Access Compliance Report Public Rights-of-Way (Curb Ramps)

Main Street: N/A		Cross Street: ESPERANZA_RD		Location:	NW
ADA ID: RPAT210923134822	Ramp Type:Type 1 - Perpendicular	Initial Pass/Fail: Pass	Overall Compliance: No	Severity Score:	9
Codes/Mitigation Info/Possible Solution			Field Measurements/Component Compliance

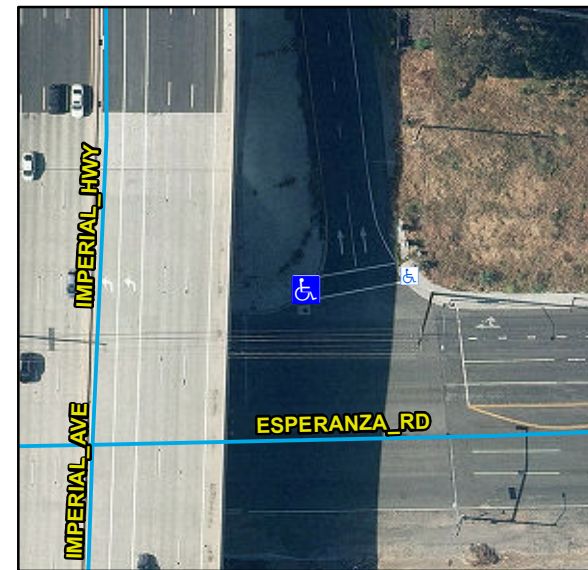
R304.2.2, R304.2.1, R304.5.4, STD 1115

Compliance	Description	Data	Compliance	Description	Data
N/A	Ramp Length (in)	68	N/A	Flare Type LT	
Yes	Ramp Width (in)	49			Sloped
Yes	Ramp Run Slope (%)	8.1	Yes	Flare Slope LT (%)	6
Yes	Ramp Cross Slope (%)	0.2	N/A	Flare Traversable LT	Yes
N/A	Landing Present	Yes	N/A	Flare Type RT	
N/A	Landing Length (in)	46			Sloped
Yes	Landing Width (in)	50	Yes	Flare Slope RT (%)	7.6
Yes	Landing Run Slope (%)	1.9	N/A	Flare Traversable RT	Yes
Yes	Landing Cross Slope (%)	1	Yes	DWS Provided	Yes
N/A	Landing Movement Obstructed?	Yes	Yes	DWS Contrast	Yes
	Landing Movement Obstructed by signal post and curb		Yes	DWS Length (in)	36
N/A	Landing Shared	No	Yes	DWS Full Width	Yes
N/A	Clear Space	N/A	Yes	DWS Offset Left (in)	0
N/A	Clear Space To Crosswalk (in)	N/A	Yes	DWS Offset Right (in)	N/A
N/A	Marked Crosswalk 1	Yes	N/A	Marked Crosswalk 2	N/A
	Crossing 1 Direction	E		Crossing 2 Direction	N/A
	Marked Crosswalk 1 Width (in)	120		Marked Crosswalk 2 Width (in)	N/A

Yes	Ramp Inside Crosswalk 1	Yes	Yes	Ramp Inside Crosswalk 2	N/A
	Crossing 1 Slope (%)	1.1		Crossing 2 Slope (%)	N/A
	Crossing 1 Cross Slope (%)	1.4		Crossing 2 Cross Slope (%)	N/A
Yes	Gutter Ponding	No	No	Curb Slope	5.6
Yes	Gutter Lip Height (in)	0		Road Run Slope (%)	N/A
No	Gutter Run Slope (%)	6.5		Road Cross Slope (%)	N/A
Yes	Gutter Cross Slope (%)	1.5			
Yes	Overall Surface Condition: Acceptable		Yes	Perp Joint Present	Yes
	Cross Gutter Present?	No		Spandrel Present?	No
	Replace Cross Gutter?	N/A		Replace Spandrel?	N/A

Remove & Replace Entire Ramp. Remove & Replace Gutter.
